Product Change Notification

1. ECN #: 237075

- BNC7T - TRUE 75 OHM, BNC STR JACK SHELL

- BNC7T-J-P-XX-ST-EM2D

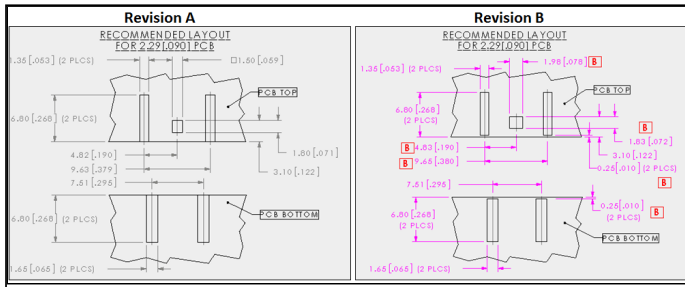
The product itself is not changing. The suggested footprint is being updated in the following ways. The center contact pad is being increased from 1.50mm to 1.98mm. The distance between ground pads are being increased from 9.63 to 9.65. The ground pads are being moved 0.25 away from the board edge.

The suggested footprint is being optimized to reduce electrical resonances at 6 GHz.
